Application Ref: **2015/5752/PRE**
Please ask for: **Fiona Davies**
Telephone: 020 7974 **4034**

Pre-application Minor development - Pre-application Advice Issued

Address:
69 Kentish Town Road
London
NW1 8NY

Proposal:
Commercial extension & 3 new residential units

Lower and upper ground plans of rear addition proposed provided with pre-application enquiry

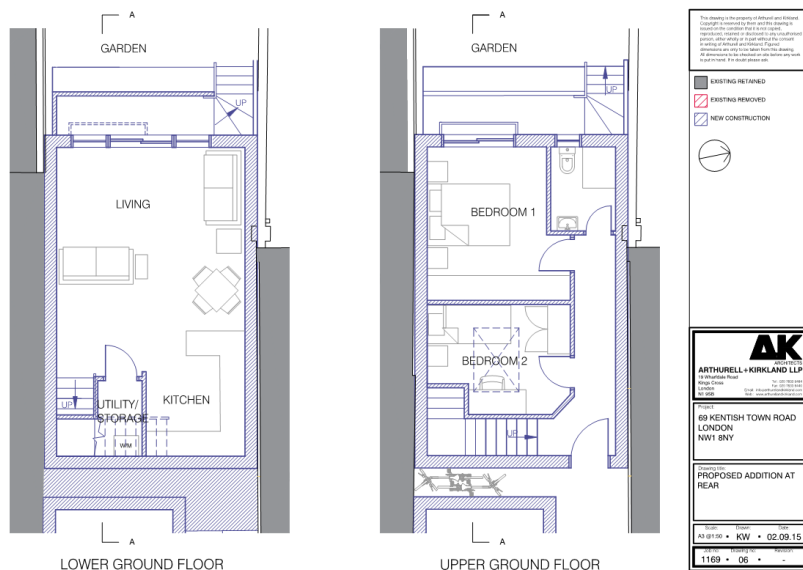
We would advise that the proposed rear addition needs to be reduced in bulk and massing. First and foremost, this can be achieved by reducing the proposed depth. As proposed, it is too deep and its depth would need to be reduced at least to no further than the depth of the extension at the adjacent property at no. 71.

At present there is a sense that the current proposed scale will create a sense of overbearing effect with potential negative impacts on residential amenity and the potential to result in over development at the site.

Furthermore it appears that the height of the proposed two-storey rear extension would exceed the height of the rear extension at the adjacent property no. 71. We would advise the height of this extension is reduced to reduce the massing of this extension.

We note that the current proposal seeks to create a separate addition to the rear. We would advise that this creates an awkward gap between the existing property and the proposed new rear addition at ground and basement level. We would advise that the proposal could be redesigned to remove what could become an awkward gap between two buildings and incorporated as a rear extension. The proposed cycle parking could be relocated either to the rear garden or to an internal storage space. A gap between the existing property and the new rear addition could still be maintained but without making the rear addition a separate building. We would recommend that the new unit to the rear is formed by a rear extension to the existing property.

We note that a balcony is proposed at ground floor level to the rear addition. Firstly we recommend that a Juliette balcony (a non-projecting balcony) may be more appropriate here. This balcony may introduce some over-looking concerns with regard to surrounding properties. This includes the residential flats located to the rear of the site which are within close proximity. The proposed balcony could introduce overlooking into the windows of these flats which serve habitable rooms.

Please note that the new rear addition 2-bedroom unit is below the recommended minimum space standard for 2-bedroom units.

We note that the second bedroom in the new unit (Flat 3) proposed will only be served by a roof light and therefore will have no outlook. This is not an ideal situation and will not provide the best living environment.

Furthermore, the proposed living room/kitchen space at basement level will be deep in plan meaning daylight might be limited and the space could be potentially dark to the back of the plan. This is of particular concern in this single aspect space.
